Council Assessment Panel Agenda & Reports

**5.1 DEVELOPMENT NUMBER 24000067 – CITY OF NORWOOD PAYNEHAM & ST PETERS –
 188 O G ROAD, FELIXSTOW**

Application for removal of significant tree and variation of existing Planning Consent.

AERIAL PHOTOGRAPH OF THE PMSC IN 1979 WHICH DOES NOT SHOW TREE 2 TO THE EAST OF THE MAIN POOL

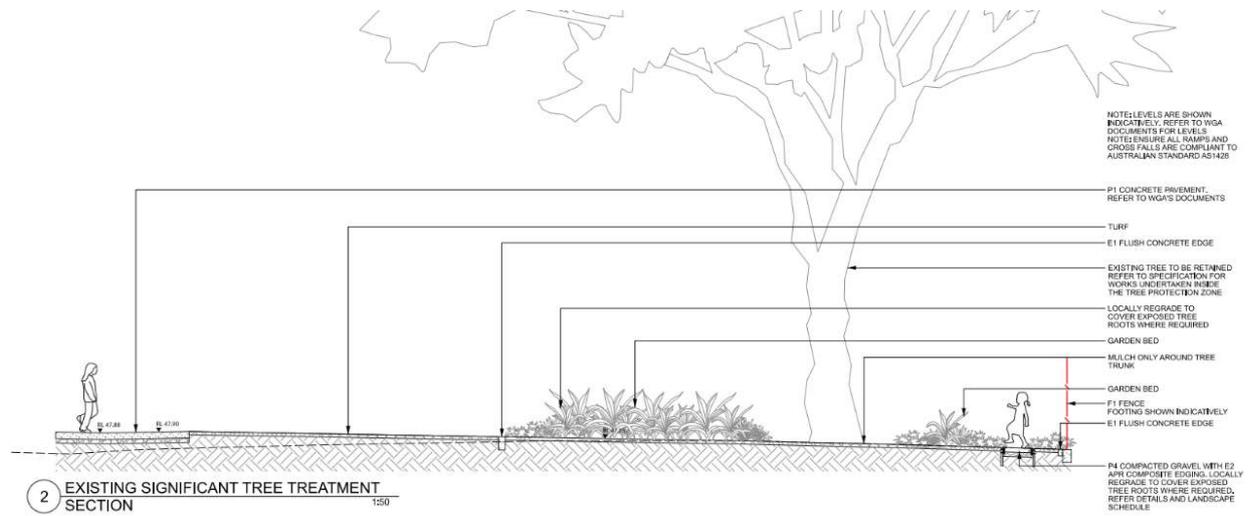
Tree 2 is not a local indigenous or remnant species. It was planted post 1979, as attested by the attached aerial photo of the site from that year and therefore definitely planted during the tenure of the existing pool facility which was built in 1968 and from the evidence of the aerial photography, it is no more than 44 years old.

CROSS SECTION OF EASTERN SIDE OF POOL IF TREE 2 IS RETAINED – slope away from pool shown

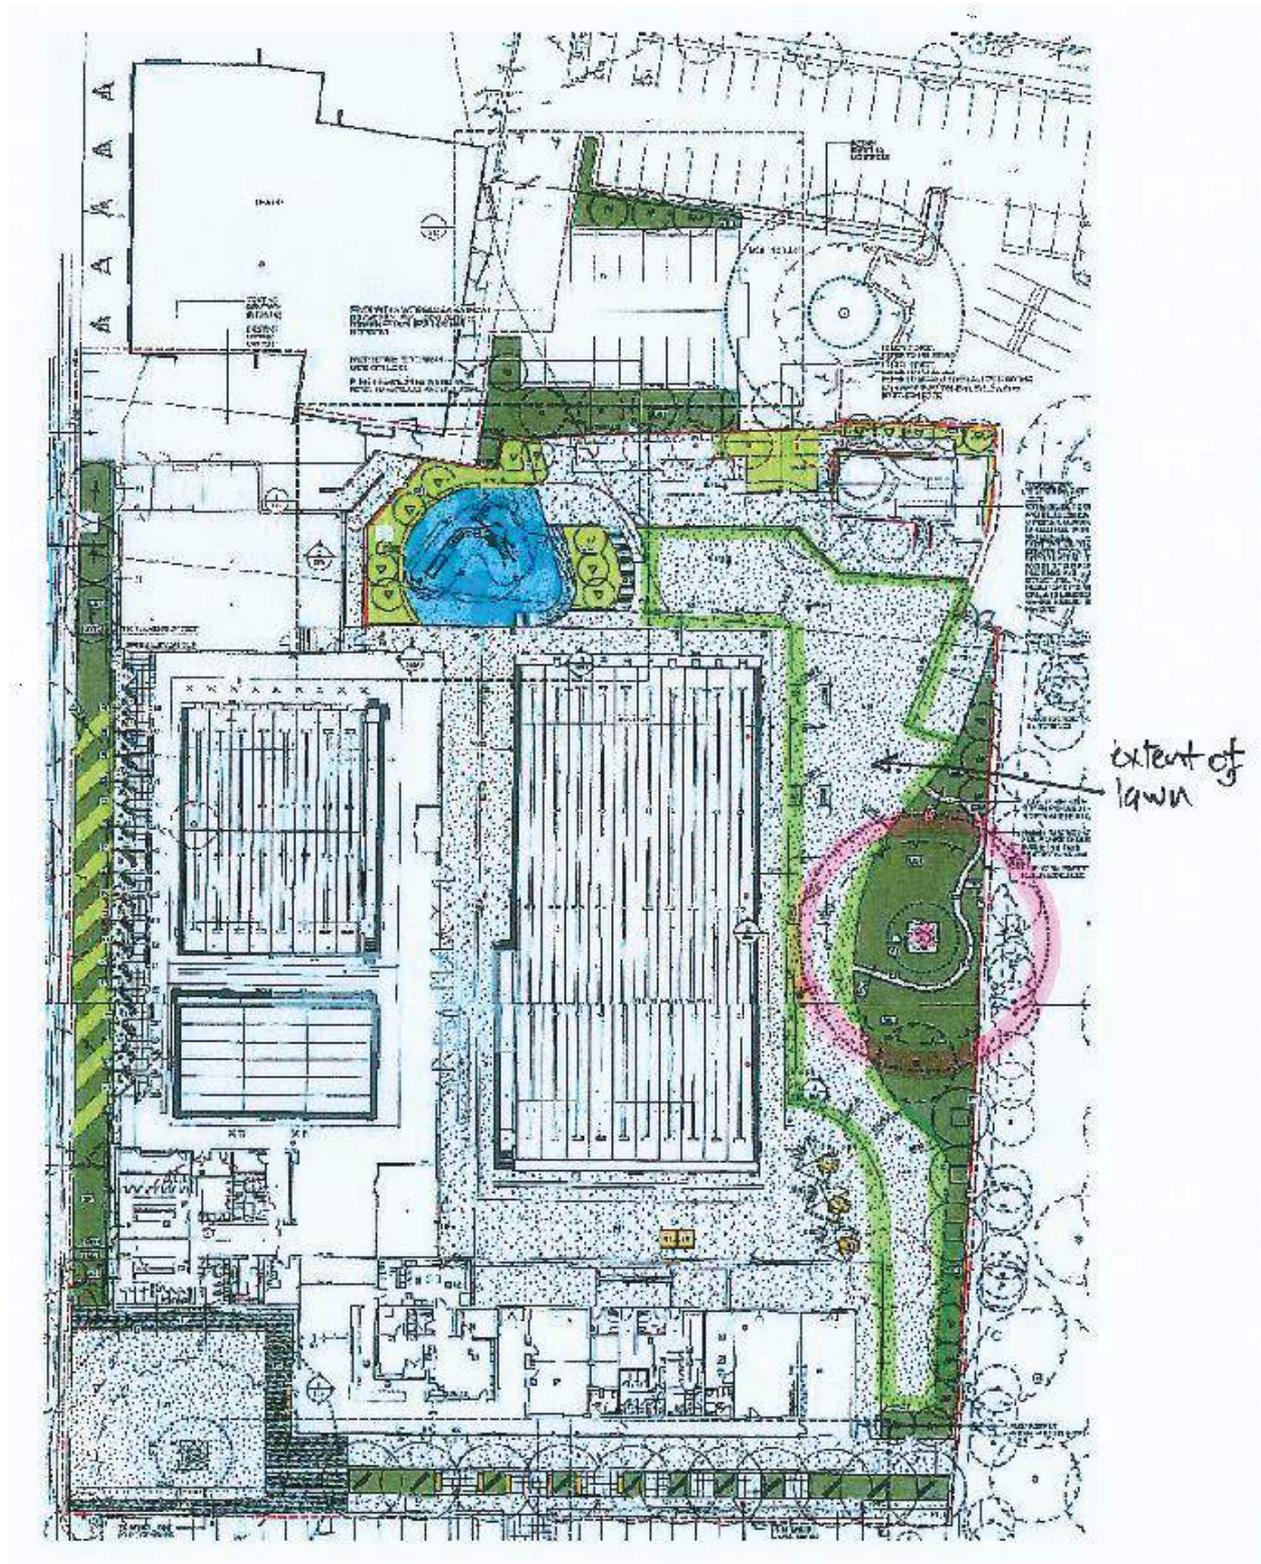
- Changes in site level in the area east of the pool can be incorporated into the new landscape plan to account for the changes in pool level in relation to the existing open space resulting in improved safety of pool users.

EXISTING LANDSCAPE PLAN OF THE EASTERN SIDE OF THE OUTDOOR POOL AREA

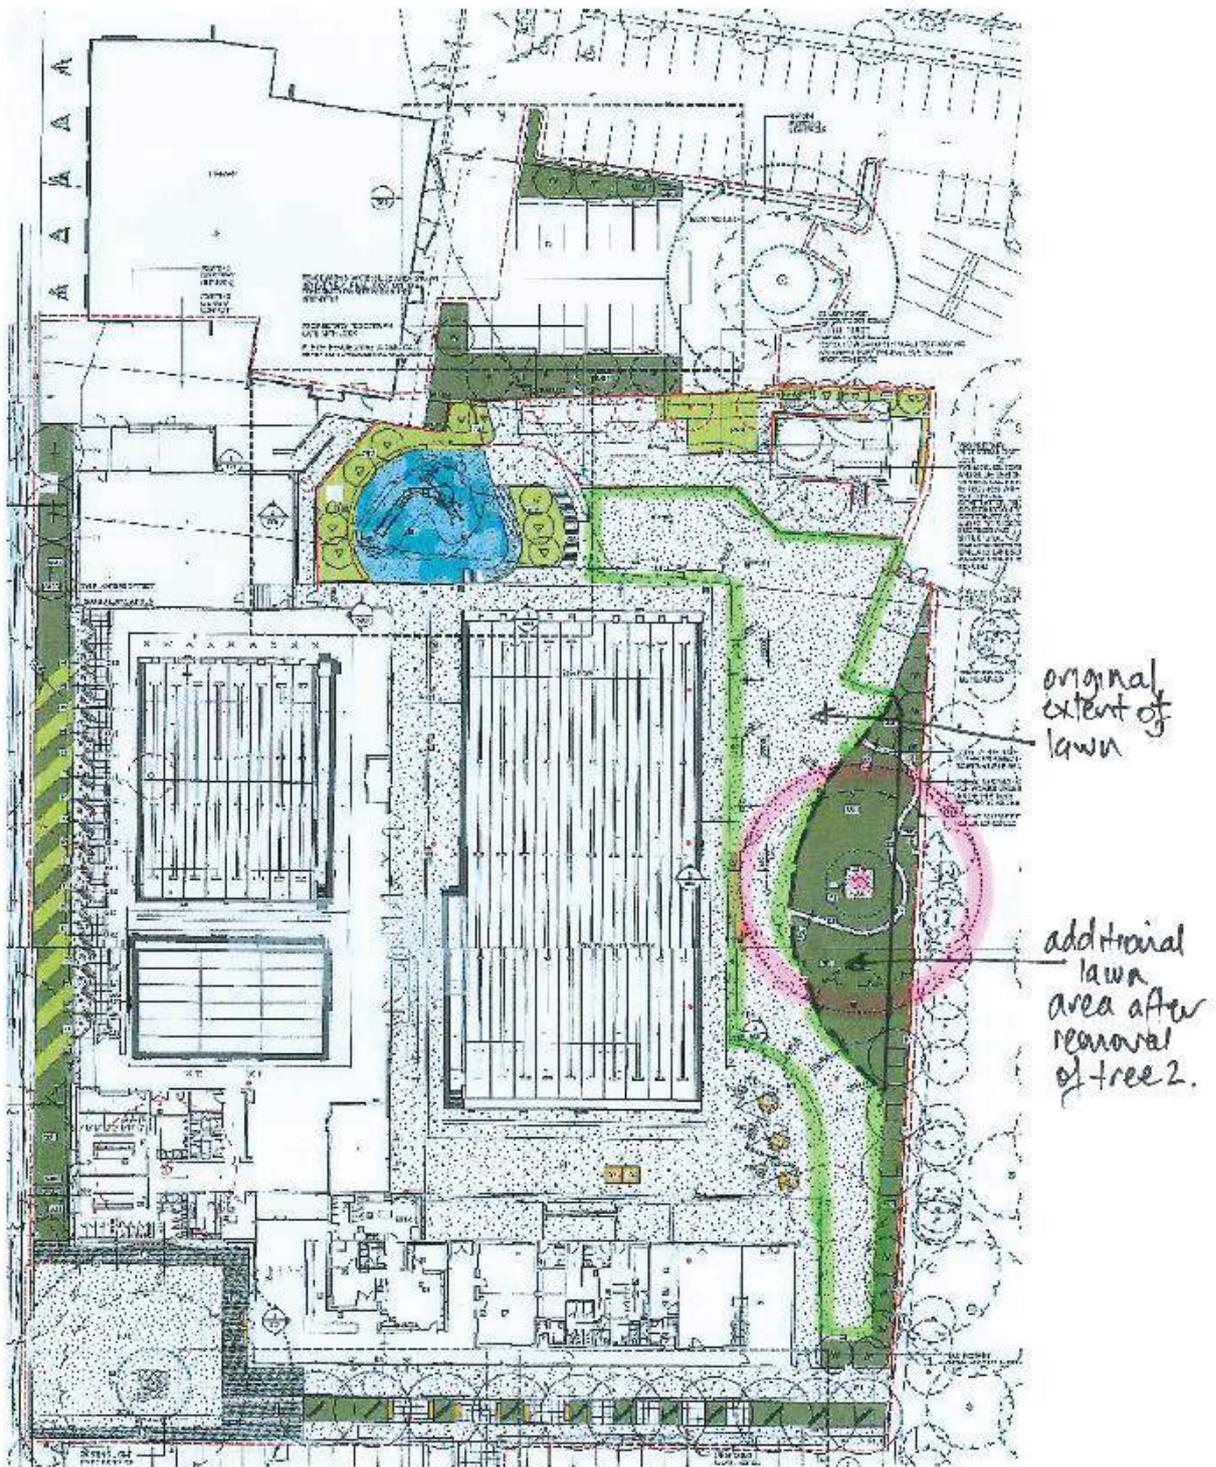
With the fear for public safety regarding limb drop, significant exclusion zones around Tree 2 were established in the attached landscape plan and the resultant mulched area significantly reduces the lawned area available to the community for recreation and picnic space.

ADDITIONAL LAWN AREA SHOULD TREE 2 BE REMOVED

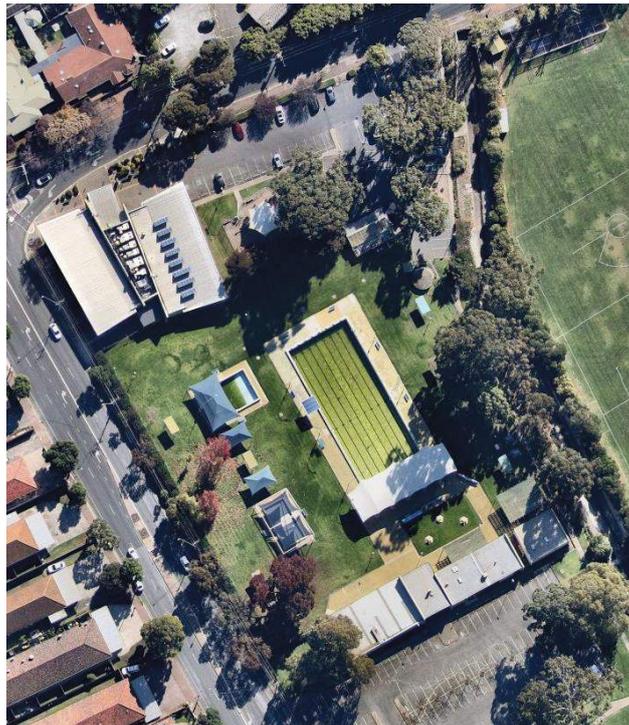
Improved landscaping and grading would allow for the introduction of appropriate shade tree plantings in locations for the best long-term outcome. The amount of lawn area would also be able to be increased thus making best use of the available open space which will be in high demand in summer months.

- Additional tree planting is possible in the expanded lawn area in locations which will provide more afternoon shade and amenity for users in the short, medium, and long-term.
